Prepared for:

**ENGINEERING PEER REVIEW
OF COAL BYPRODUCTS DISPOSAL PLANS**

**KINGSTON FOSSIL PLANT
KINGSTON, TENNESSEE**

November 2004

DATE:	27 OCT 2004	SCALE:	1" =
PROJECT NO.	GR3471-01	FILE NO.	3471F004.DWG
DOCUMENT NO.	-	FIGURE NO.	2

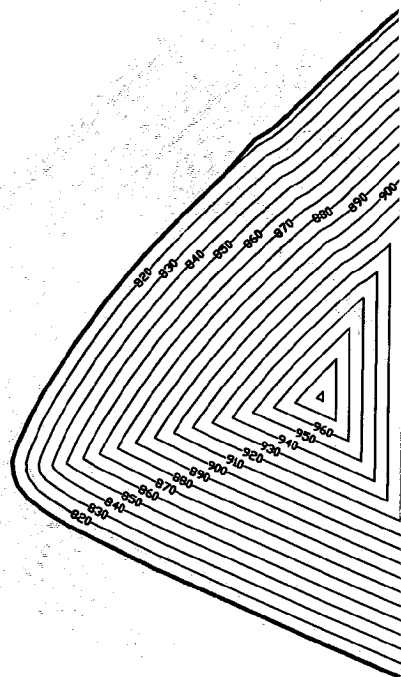
- The first option is shown in Figure 2 and was previously presented to TVA during the teleconference. This figure presents the final cover grades for both the ash and gypsum monofills. The concept maintains a 25 acre ash pond within the northwest portion of the existing ash pond and provides disposal capacity for approximately 3,000,000 cy of gypsum.

DATE:	27 OCT 2004	SCALE:	1" =
PROJECT NO.	GR3471-01	FILE NO.	3471F004.DWG
DOCUMENT NO.	-	FIGURE NO.	3

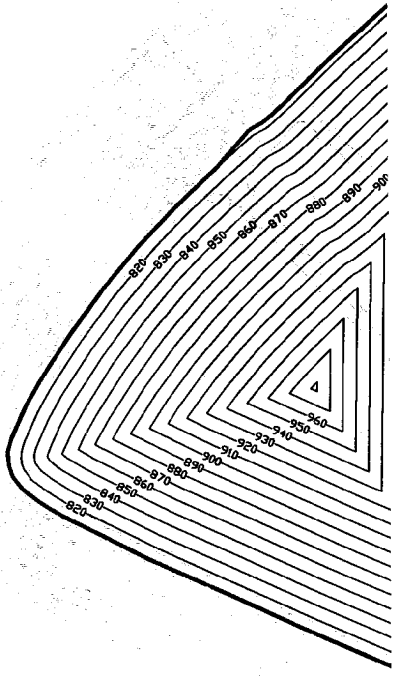
- The second option is shown in Figure 3 and was developed after the referenced teleconference. This figure also presents the final cover grades for both the ash and gypsum monofill. This concept presented on this figure also maintains the 25 acre ash pond, but limits gypsum disposal to the northeastern portion of the existing pond. Because this latter option takes advantage of the "layover" against the future ash monofill, the disposal capacity increases significantly to approximately 7,300,000 cy.
